Please submit a final draft of this document.

SOIL AND GEOLOGY STUDY

Hay Creek Road
Lots 1-6,
El Paso County, Colorado

SHEET No.
FIG-8

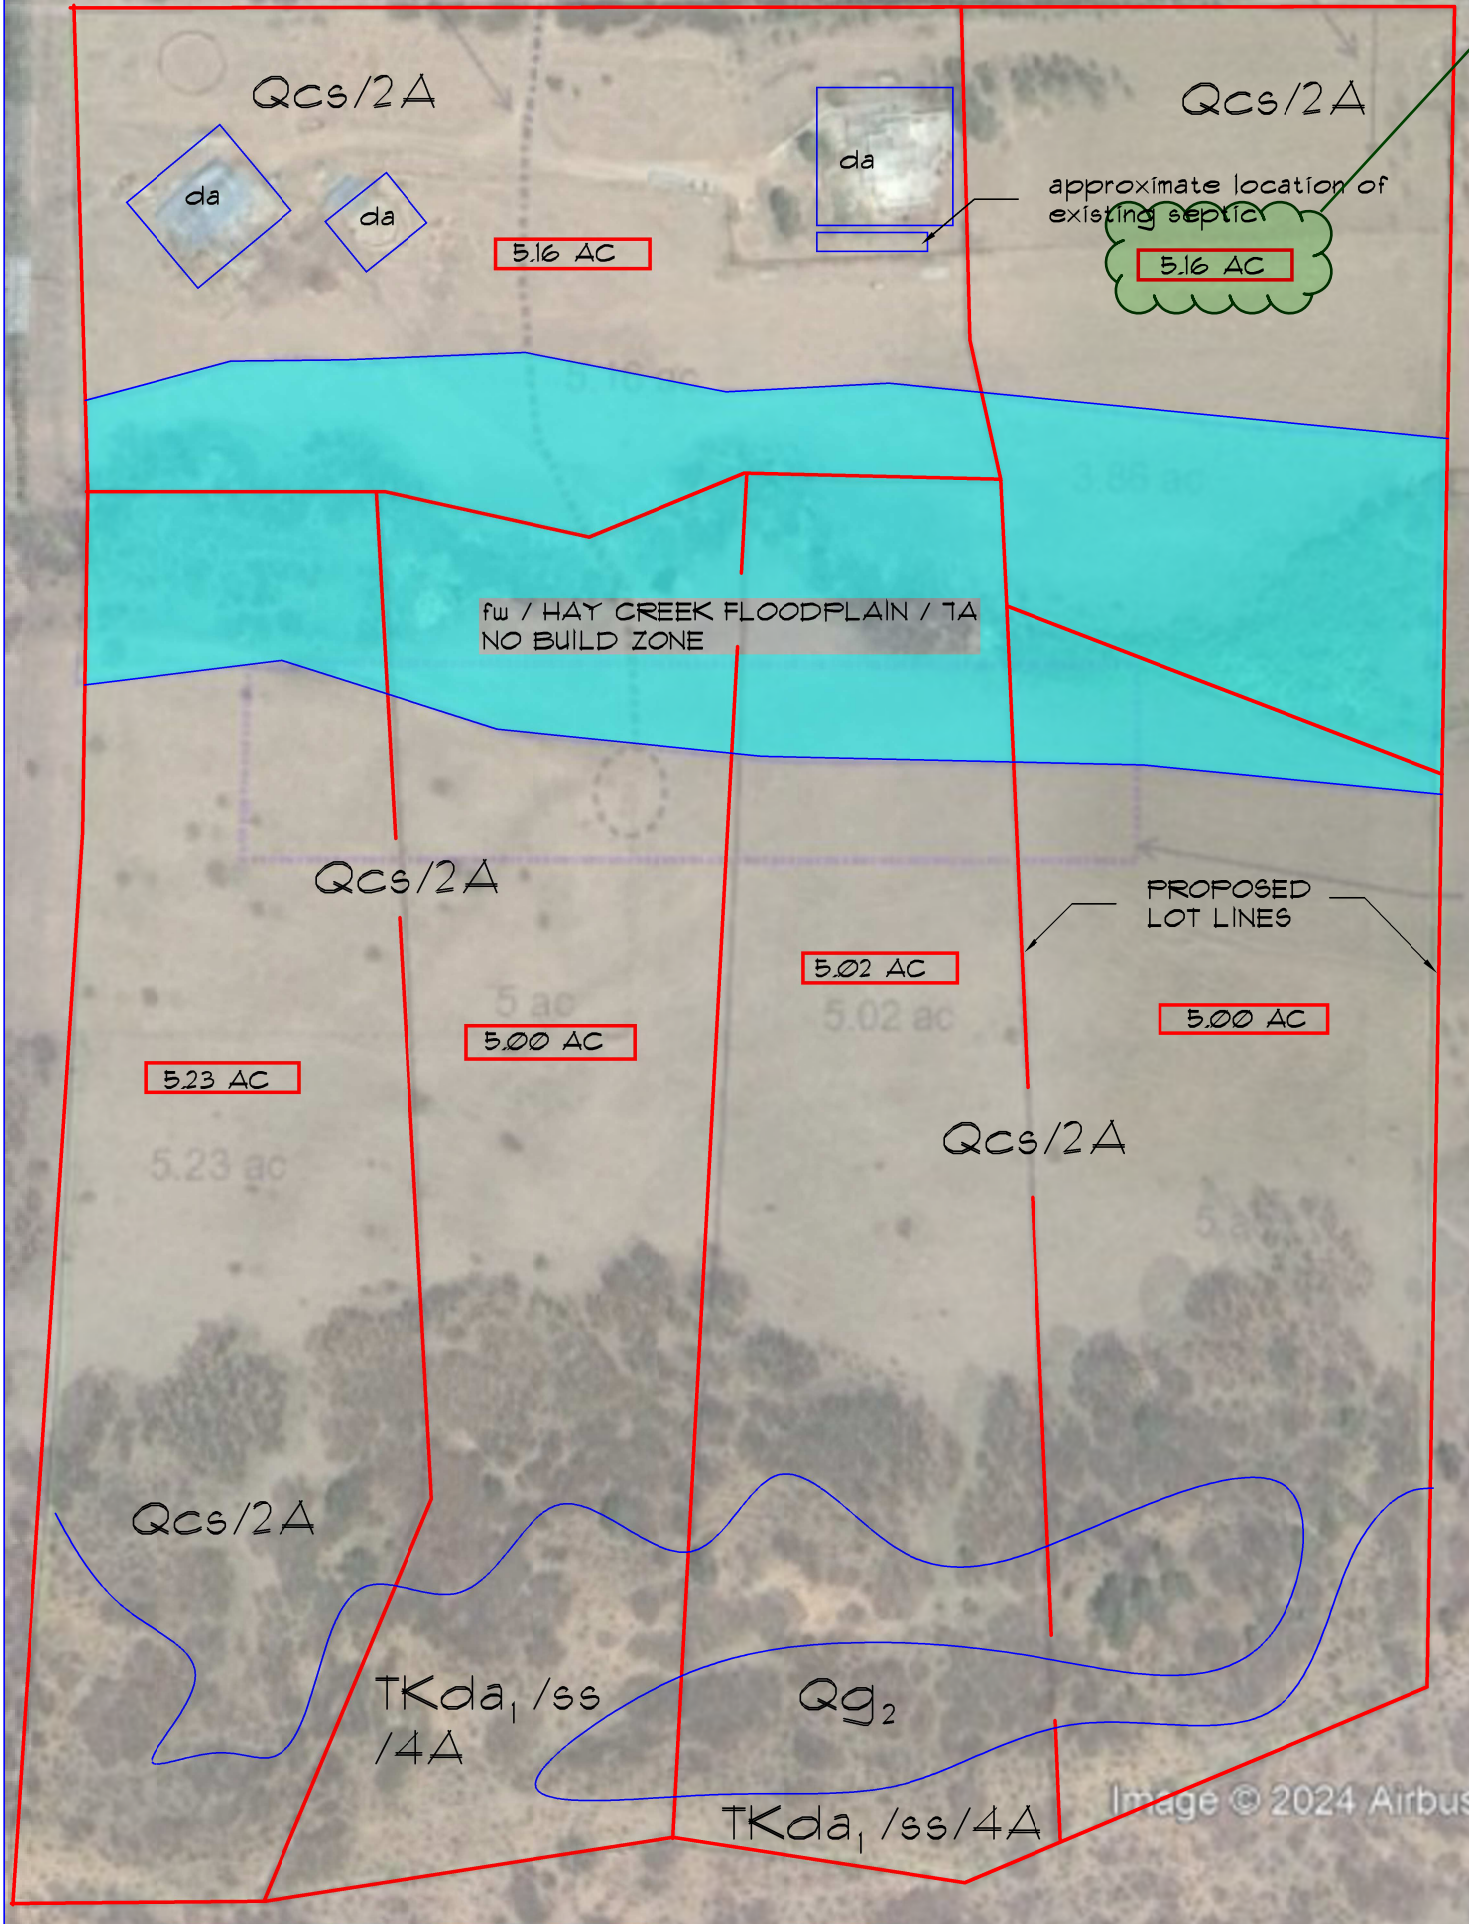
Please use current lot size configuration.
